**RE: ABP-318758-23 – WESTGATE 2040, DROGHEDA, CO. LOUTH – PUBLIC REALM REGENERATION WORKS**

This letter has been prepared by Turley Planning Ireland Ltd and members of the wider Westgate Design Team, on behalf of Louth County Council, in response to An Bord Pleanála's (hereafter 'the Board') recent request to make submissions or observations in relation to the 11 no. submissions received by the Board during the public consultation stage of the Westgate 2040 planning application process.

This letter focuses on material planning considerations raised in the 11 no. submissions received by the Board. Comments have been grouped into the following themes and responses provided:

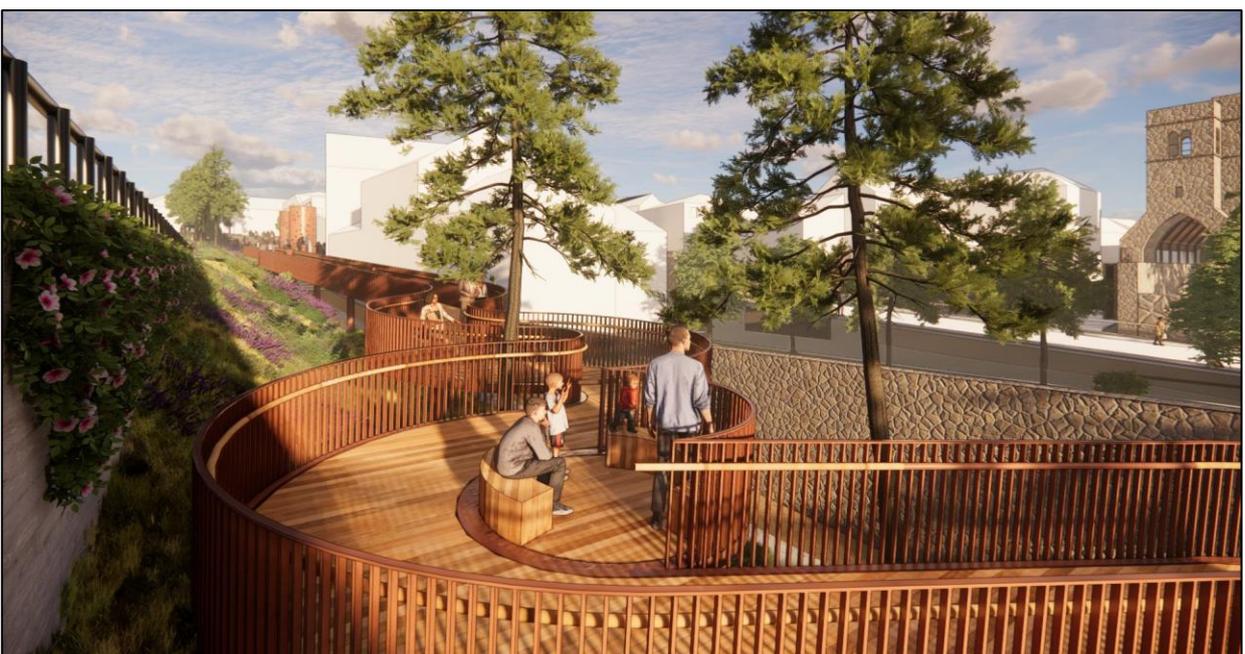
It is important to note that the area of the former medieval town wall has been incredibly challenging from a design perspective noting the difficult topography levels and that the site is constrained by the former medieval town wall to the east and the road/bridge infrastructure including its retaining wall and embankment to the west. The area is also ‘cut off’ from general public access and has become overgrown and a location for antisocial behaviour with the former medieval wall being subjected to graffiti, as illustrated in the photo below.

As outlined in Chapter 4 of the EIAR, entitled ‘Consideration of Alternatives’, a total of three design options were considered for the former medieval wall area. The preferred design option, i.e. the proposals submitted to the Board, represents the softest and least dominating design solution which can also achieve universal (Part M) access through the area.

The proposals have been designed to provide a renewed focus on, and better present and integrate, the upstanding remains of the former medieval town wall by ‘opening’ the area up to allow the public to access and better experience the town wall. The proposals will also deliver a mix of high quality soft and hard landscaping interventions to deliver a medieval garden feel and an enhanced user experience. The new raised walkway will contain seating opportunities for users to stop and relax, to view the former medieval wall and also to view the Old Abbey structure, as illustrated in the computer-generated artistic impression below.
